STAFF REPORT

CONCERNING APPLICATION FOR A CERTIFICATE OF APPROPRIATENESS

Application Number: 2019-0108

Property Location: Leeper Park

Diagram 2 - Location of Well

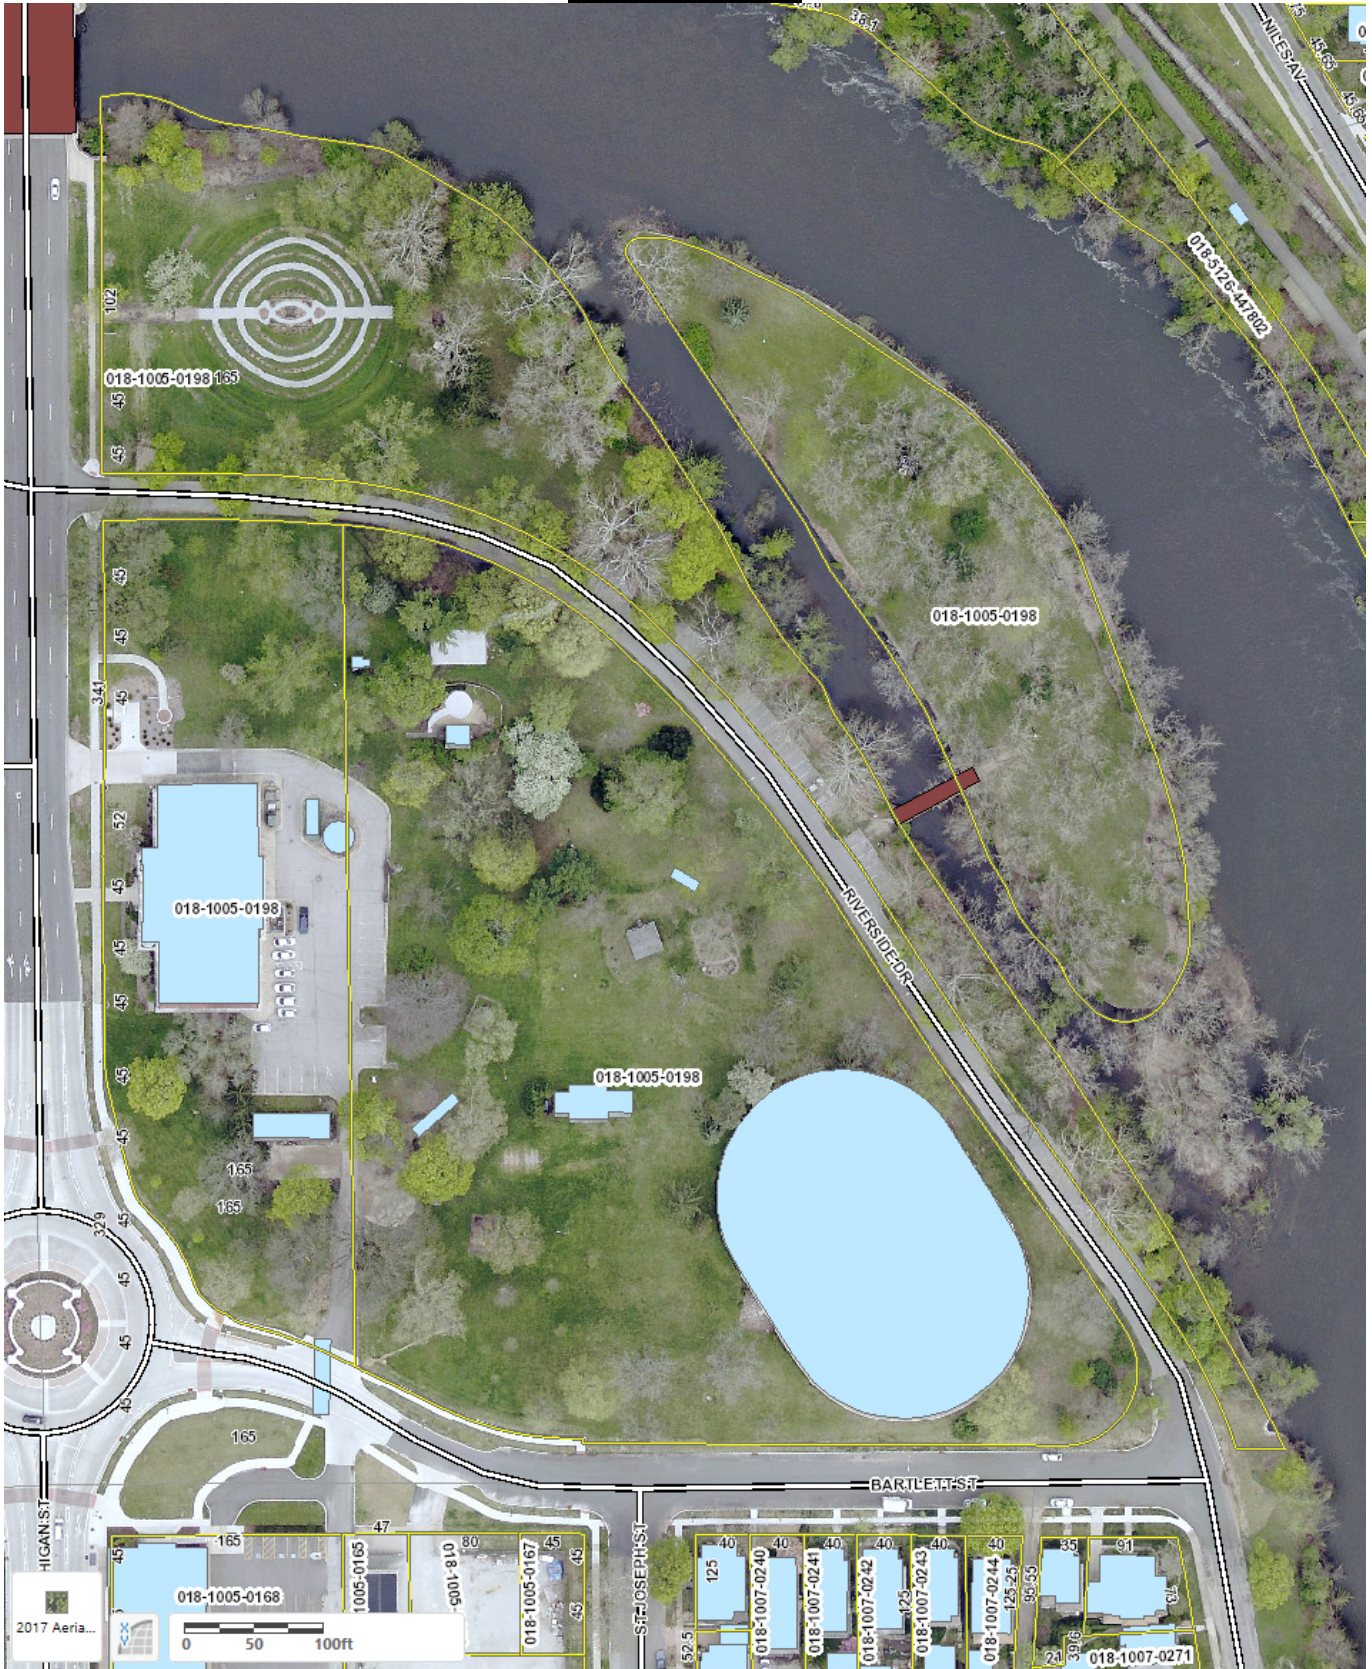
STAFF RECOMMENDATION: Staff recommends approval of the project with a condition that consideration is given to screening the well with compatible plant material.
